I would like to request that ACTIA be notified regarding the following issue. DA201833361 on Block 4 Section 46 (19 Forbes Street) Turner has been lodged to seek approval for the construction of four units with a basement car park, landscaping and other associated works, and for the demolition of an encroaching driveway. The adjoining neighbour on Block 3 Section 46 Turner (21 Forbes Street), [REDACTED], [REDACTED] has also written to the Minister regarding the existing verge crossing for his block (Block 3). The common boundary between Blocks 3 and 4 is at an angle and the verge crossing does not align with this common boundary. As a consequence, the internal driveway to [REDACTED] property encroaches into the neighbouring block (Block 4), which is proposed to be re-developed. It should be noted the common boundary fencing between Blocks 3 and 4 has been erected in an incorrect alignment and does not follow the true alignment of the common boundary.

DA Number: 201833361
Site Details: Block: 4, Section: 46
Suburb: TURNER, District: CANBERRA CENTRAL
Applicant Name: Emma Conant
Information Required: Hi [REDACTED], Following a quick assessment of the application for 4/46 Turner, I ha

SITE PLAN
 SCALE 1:200@A2
 07/03/2018
FSP003

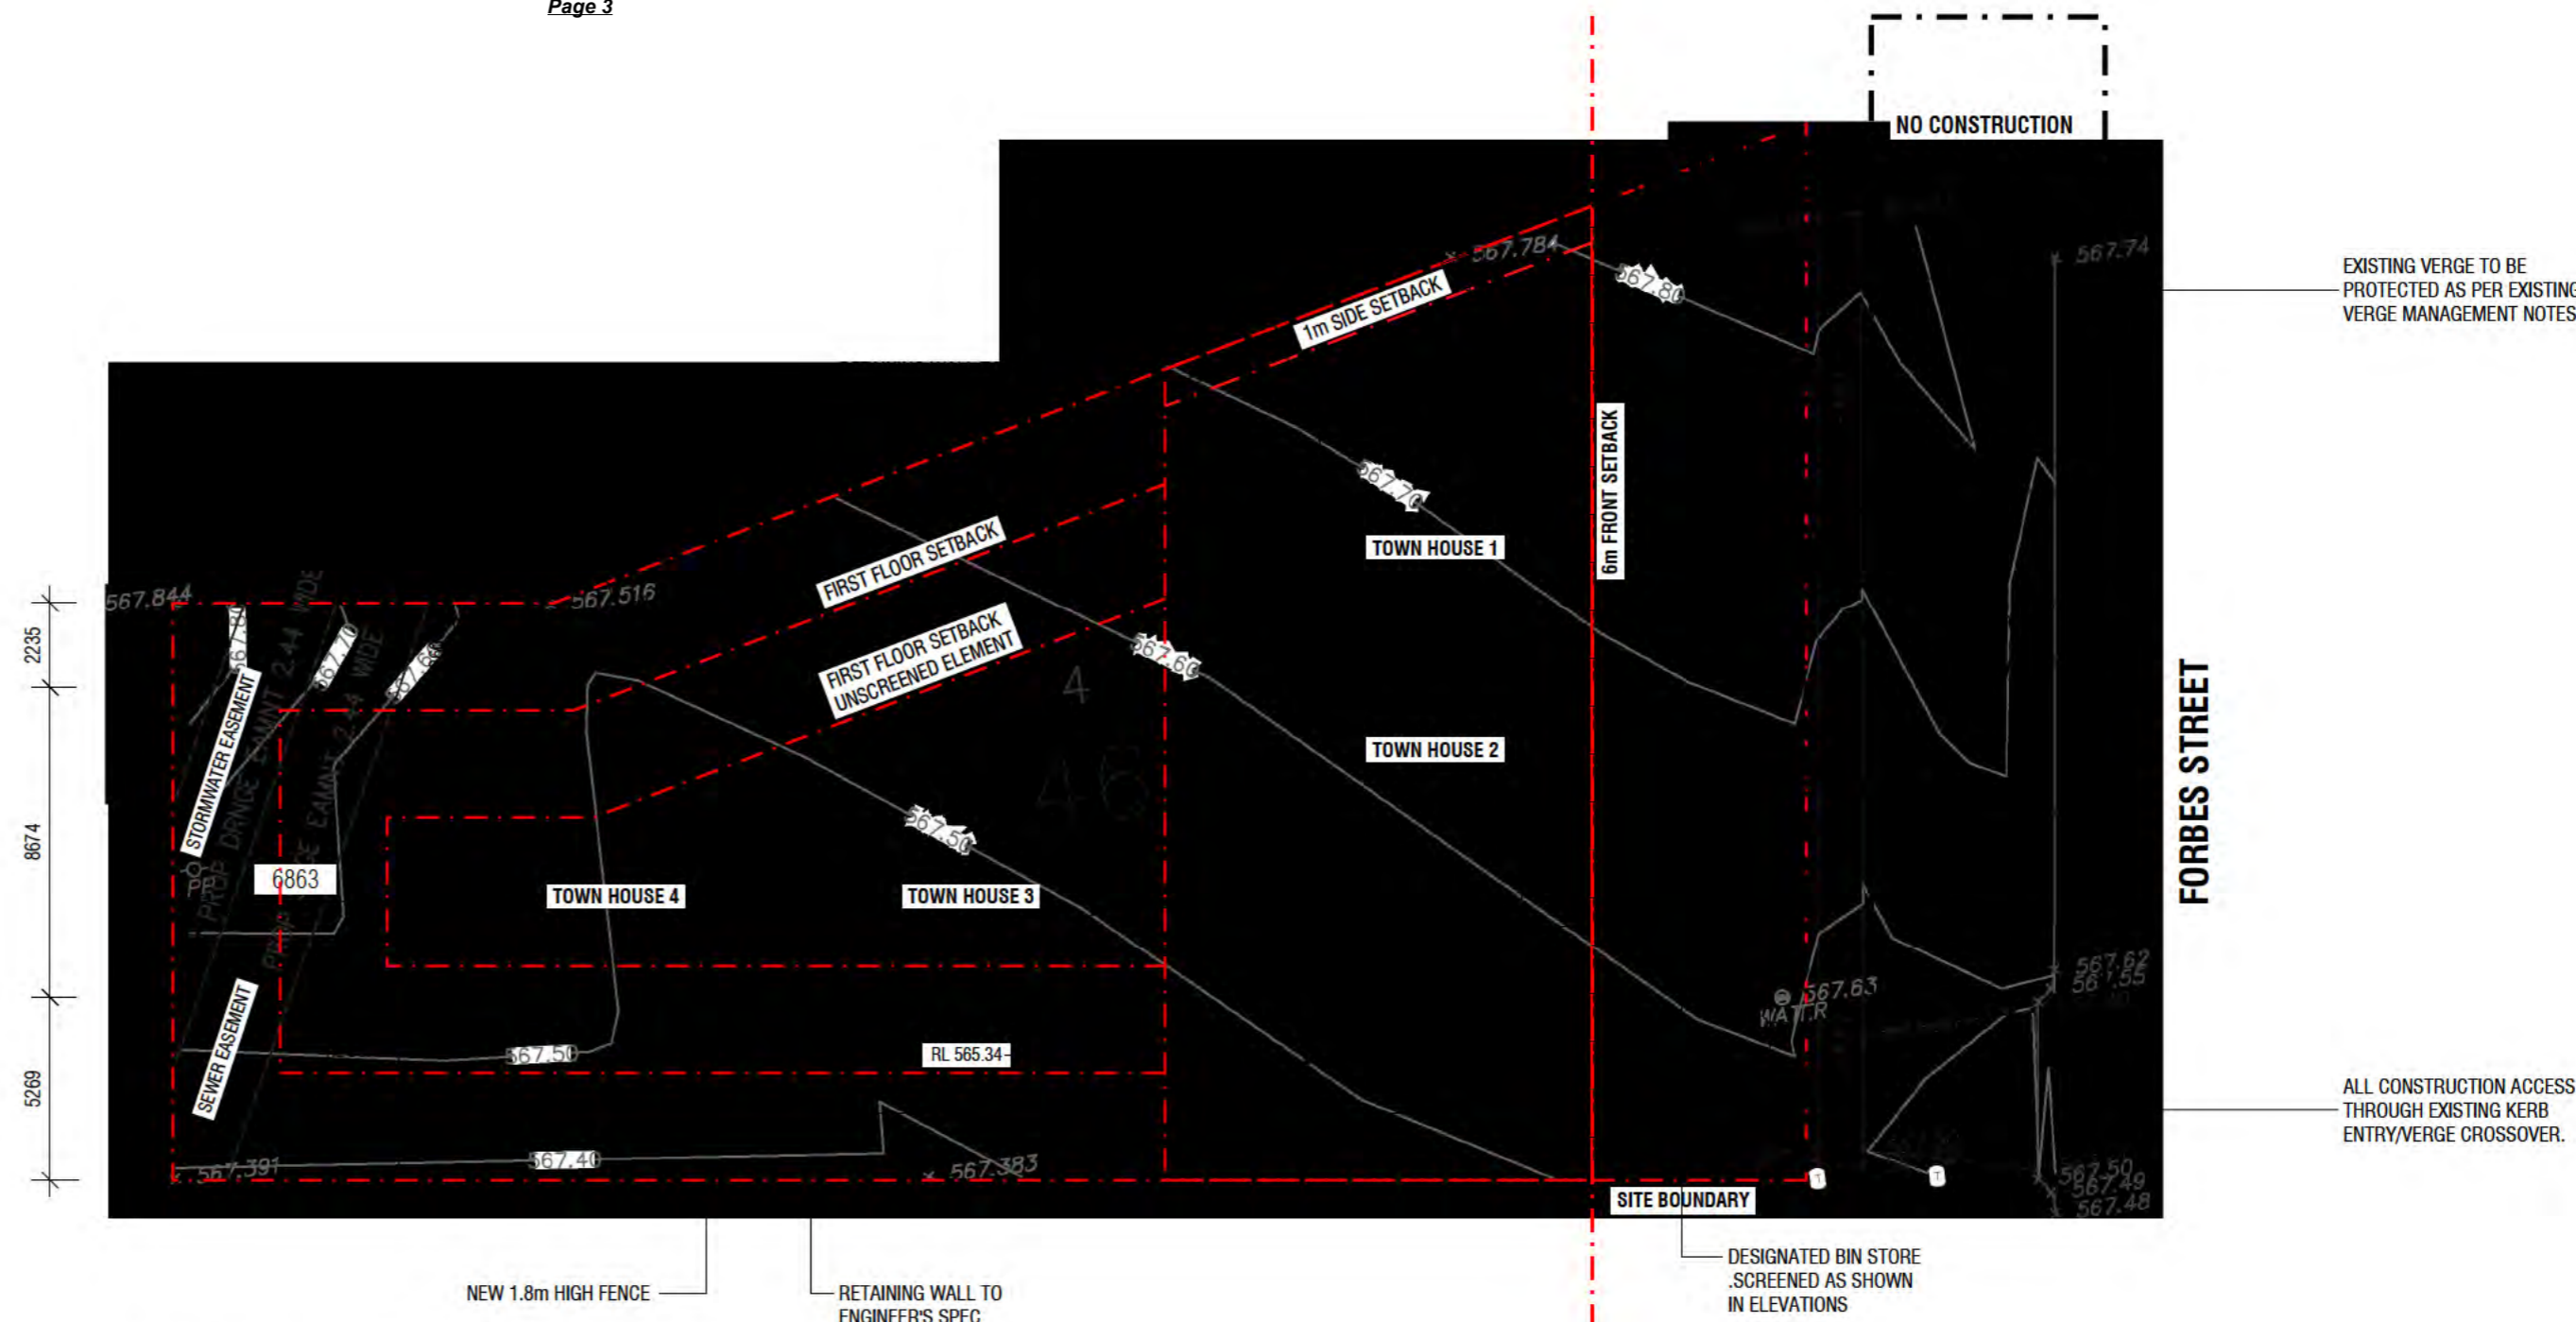
The re-development proposal includes demolition of part of the internal driveway to Block 3. [REDACTED] claims that the verge crossing was constructed by the Government more than 30 years ago in the wrong location and the internal driveway and the common boundary fence followed the alignment of this verge crossing. He has advised he bought the property in this form 32 years ago. [REDACTED] wants this driveway issue to be resolved prior to making any determination on the DA. Verbally [REDACTED] has advised that as the Government was responsible for the construction of the verge crossing, they should be liable for any losses incurred by him.

SHADOW DIAGRAMS
 SCALE 1:200 @ A2
 14/08/2018
FSP006

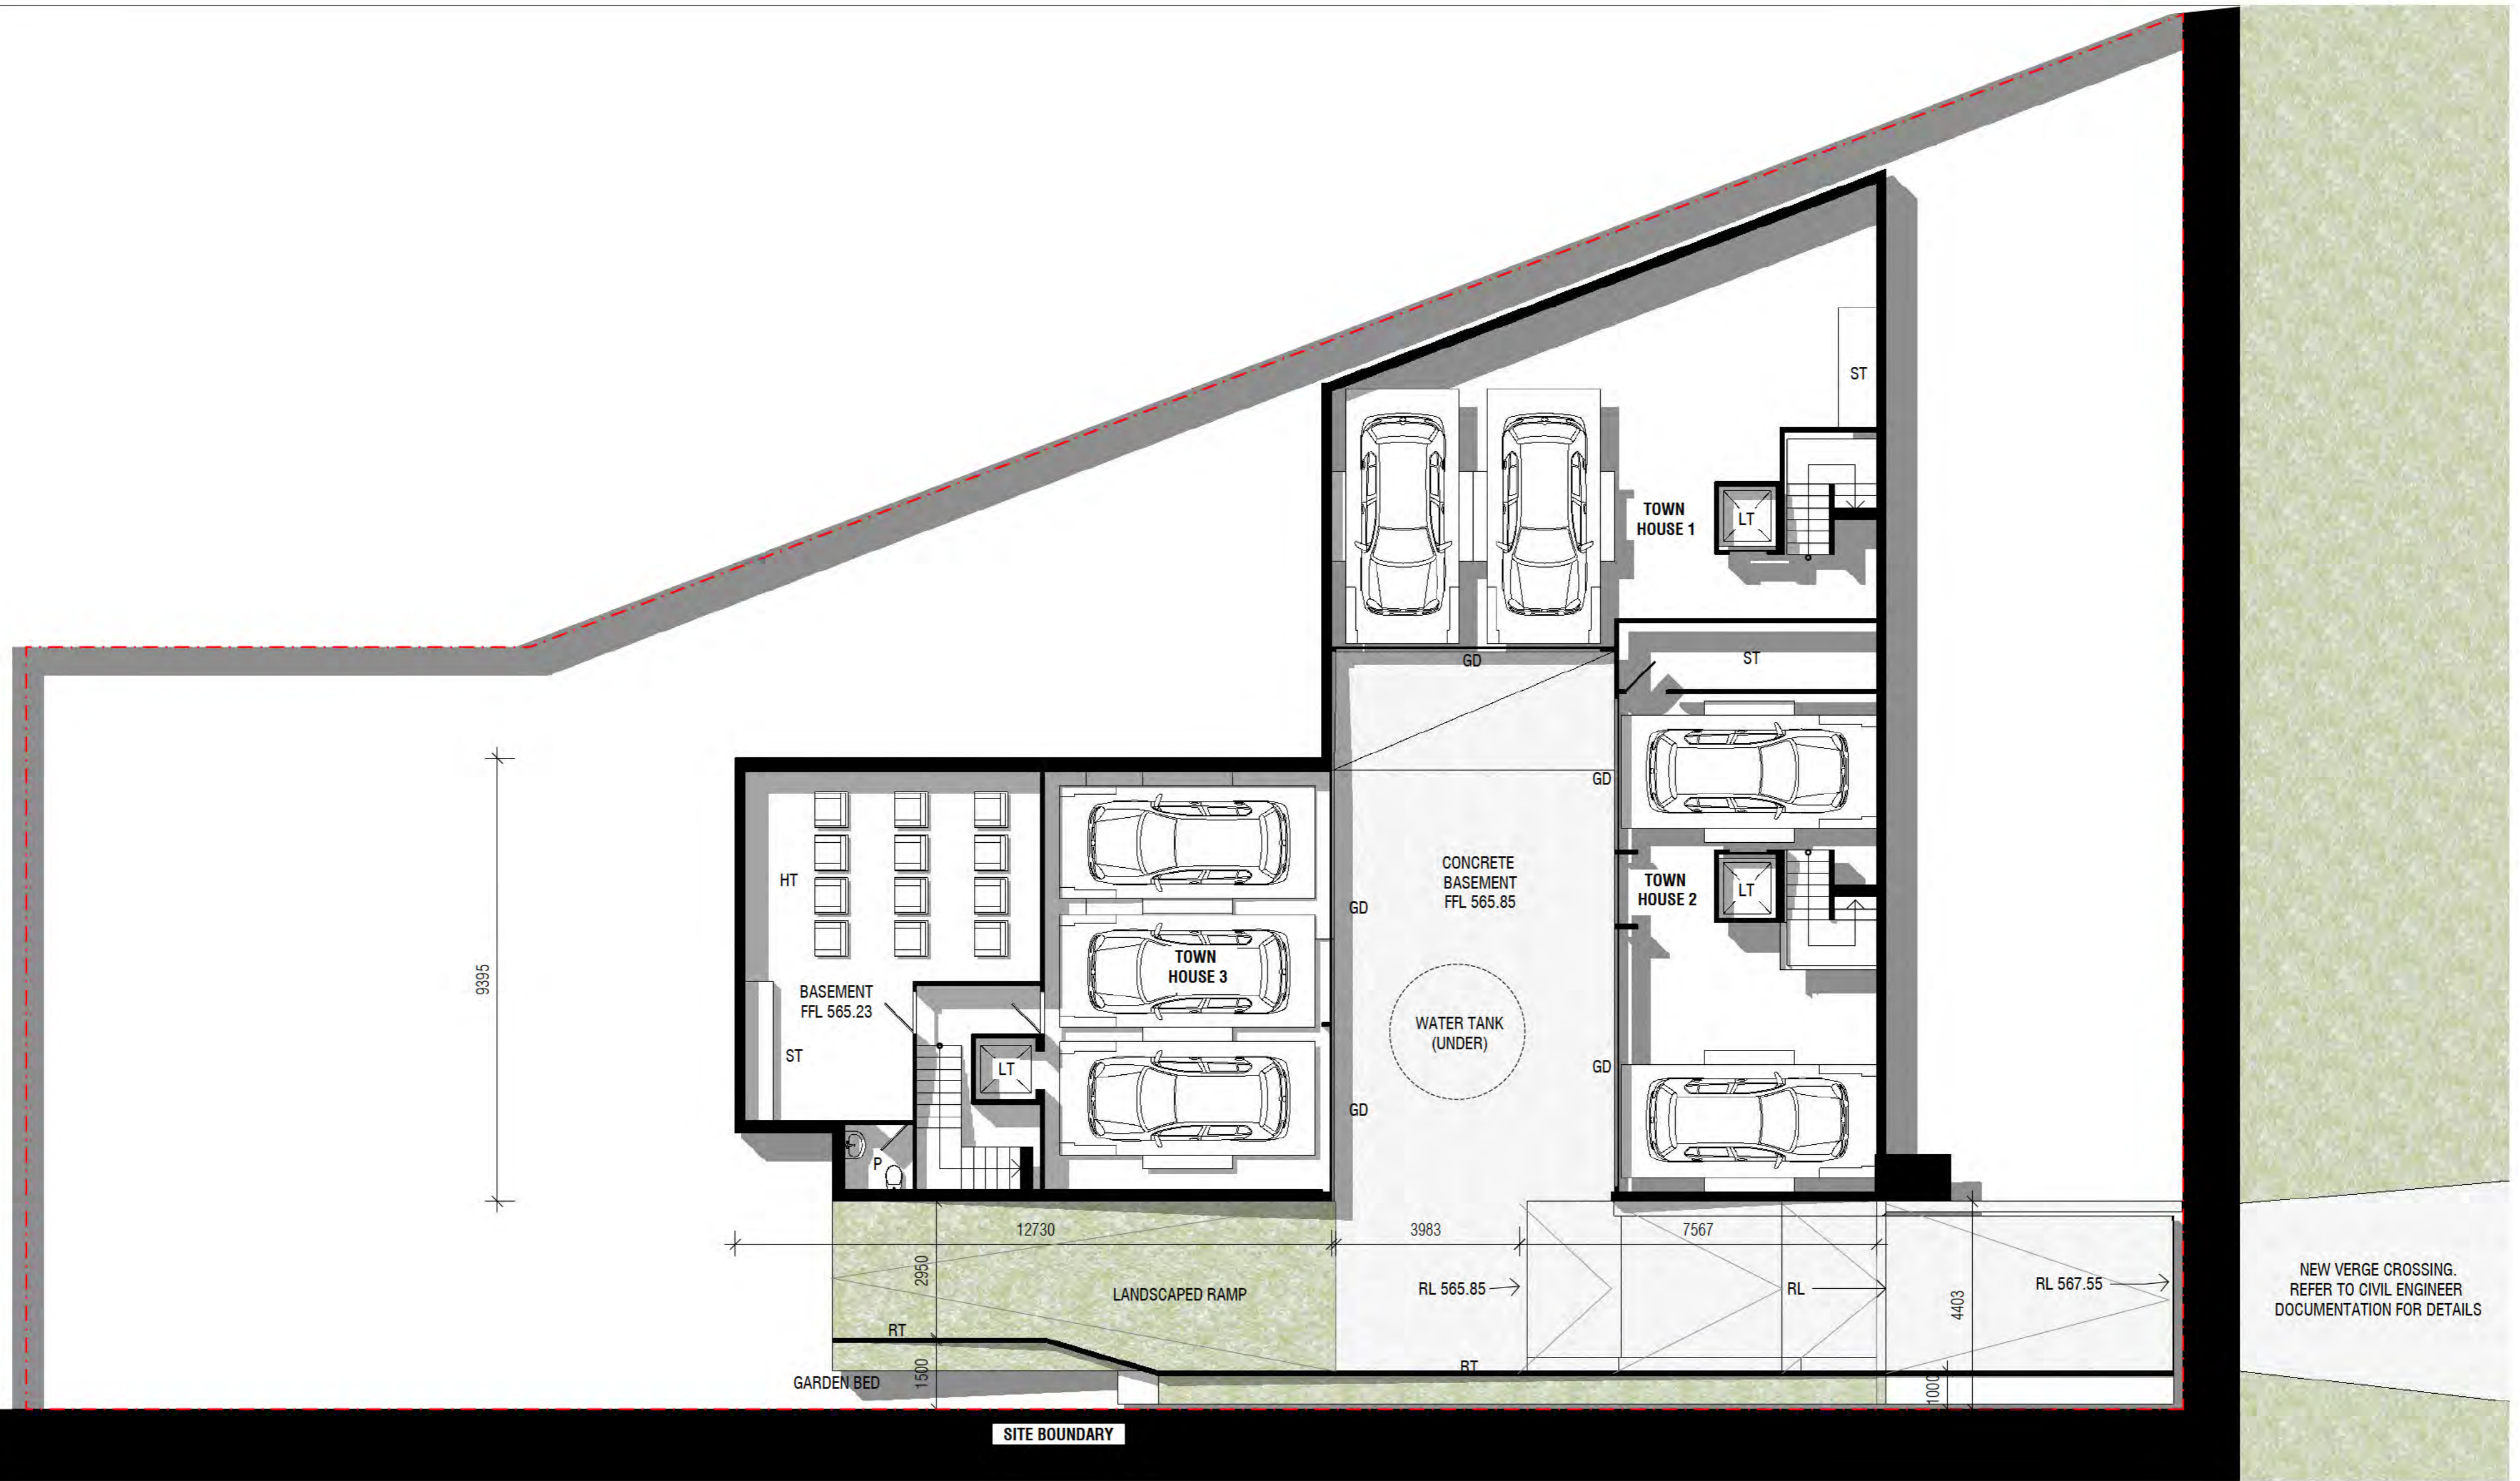
Response: Envelope encroachment has been reduced in updated designs. Shadow diagram provided to demonstrate encroachment does not significantly impact solar access on the neighbouring block.
